DSP-15009
AC-17018

STAFF REPORT

SUBJECT: Detailed Site Plan DSP-15009
Type 2 Tree Conservation Plan TCP2-029-2016
Alternative Compliance AC-17018
Redeemed Christian Church of God, Lanham

TYPE II TREE CONSERVATION PLAN

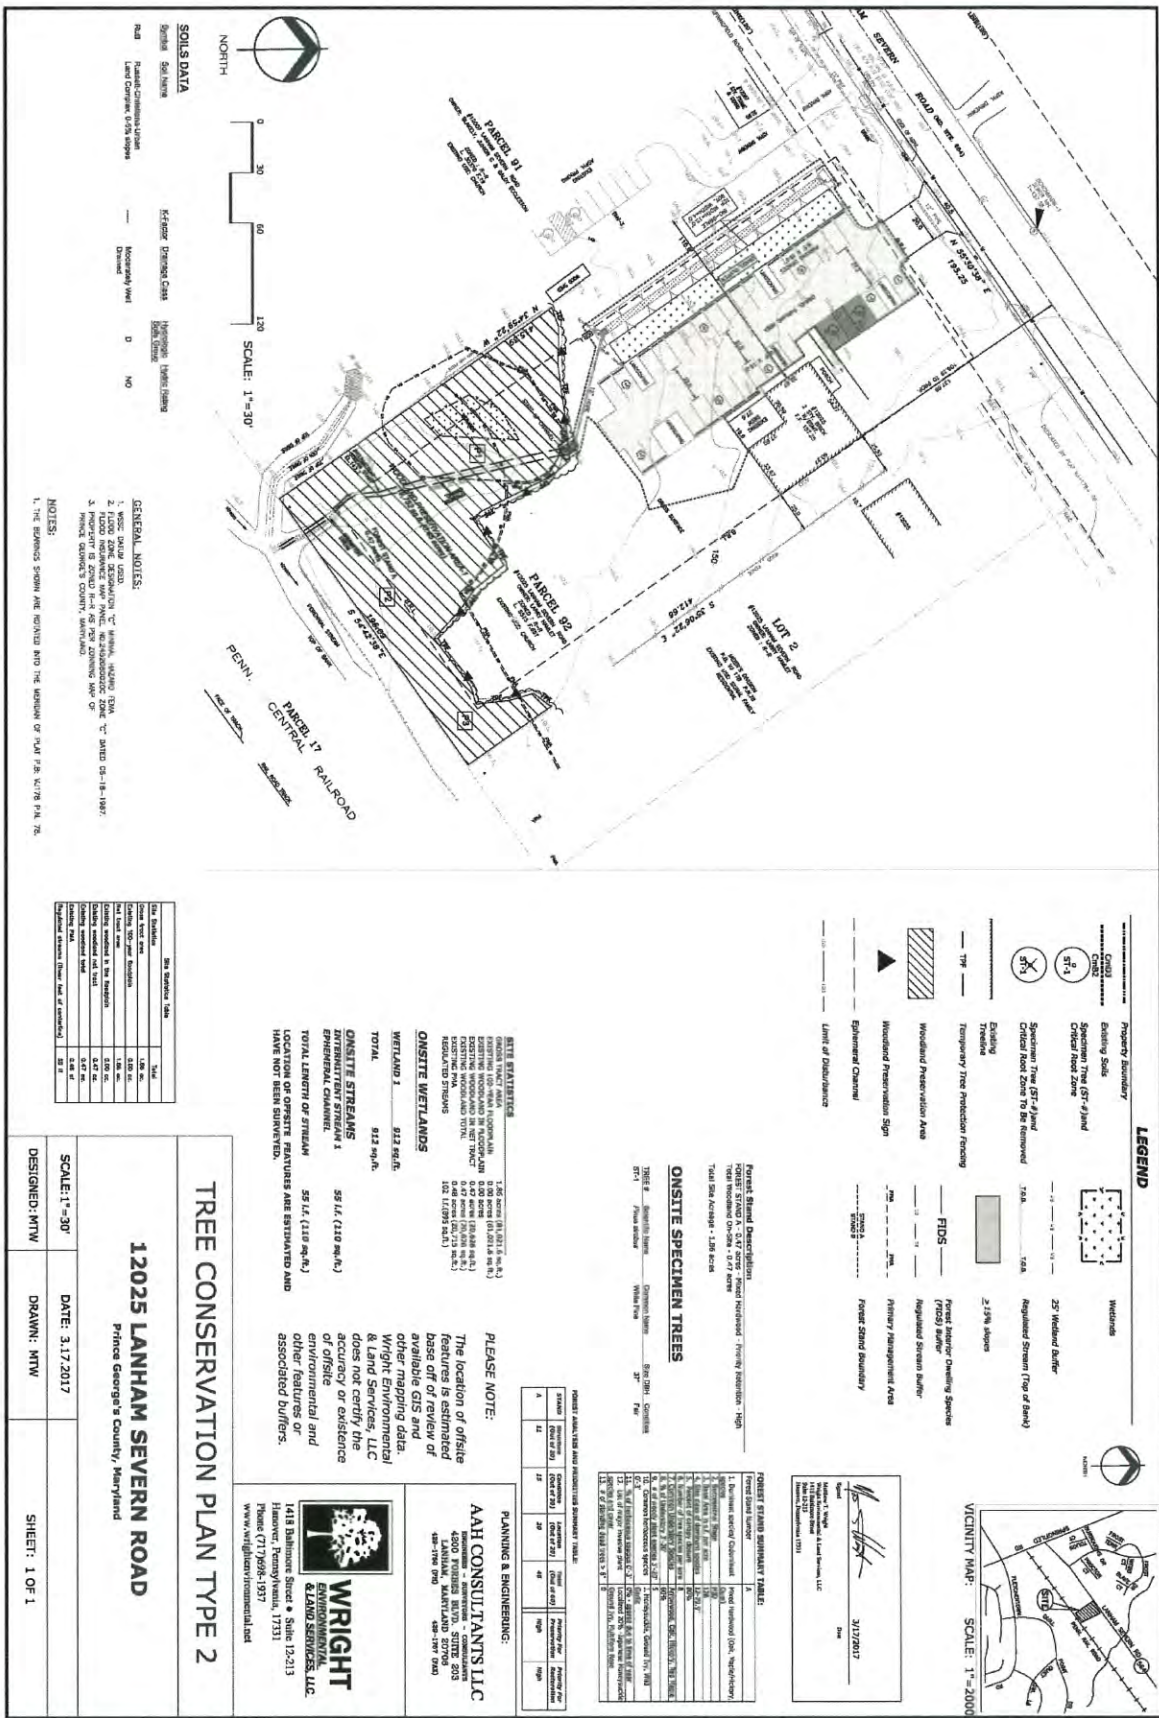
The associated worksheet on the submitted TCP2 shows that the site has a woodland conservation threshold of 15 percent and a woodland conservation requirement of 0.29 acres; however, the correct threshold for land zoned R-R is 20 percent. Upon review of the proposal with the official woodland conservation worksheet and the correct zoning, the woodland conservation requirement is 0.38 acres. Because the applicant proposes to preserve 0.45 acres of woodland conservation which is more than the requirement, conformance with the Woodland Conservation Ordinance can be satisfied with a condition to revise the worksheet.

2. Prior to signature of the Type 2 tree conservation plan (TCP2), the following revisions to the TCP2 shall be made:
 - a. Revise the worksheet to show the correct zoning of the property as Rural Residential.

- b. Add the symbols used to represent the wetland buffer and intermittent stream to the legend.
 - c. Add a column to the Specimen Tree table to indicate that Specimen Tree 1 (ST-1) is to be saved.

- d. Add the TCP2 approval block to each sheet of the TCP2, with the TCP2 number included.

- e. Remove the Forest Stand Summary table from the TCP2.
 - f. Identify the location of Specimen Tree (ST-1) on the plan with its critical root zone, in accordance with approved Natural Resources Inventory NRI-144-14-01.

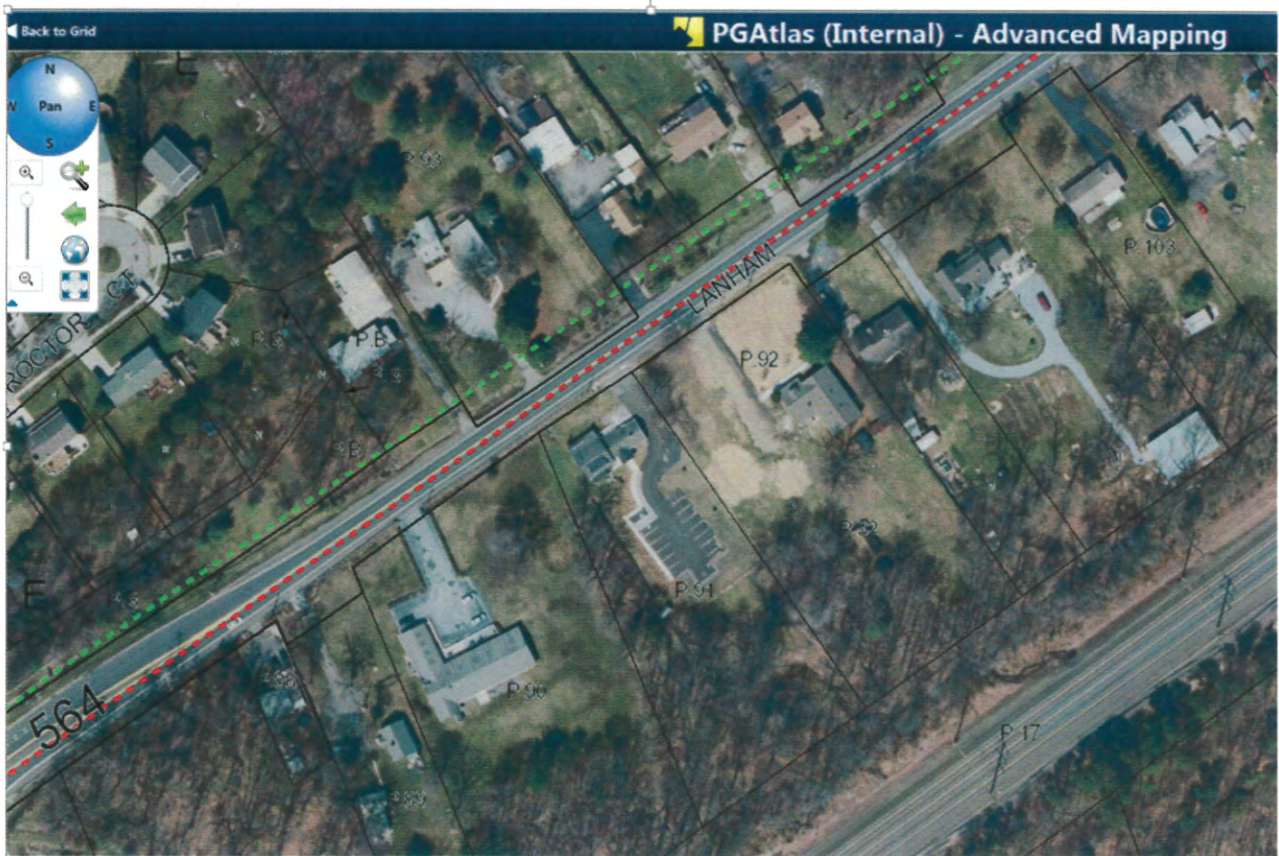
Consistent with these policies and the frontage improvements required in the vicinity of the subject site, the provision of a standard sidewalk along the site’s entire frontage of MD 564 is recommended. Also, one sidewalk connection is recommended from the public right-of-way along MD 564 to the building entrance. Suggested locations are marked in red on the attached plan sheet.

- a. Provide a standard sidewalk along the subject site’s entire frontage of MD 564, unless modified by SHA.
- b. Provide one sidewalk connection from the public right-of-way and sidewalk along MD 564 to the building entrance.
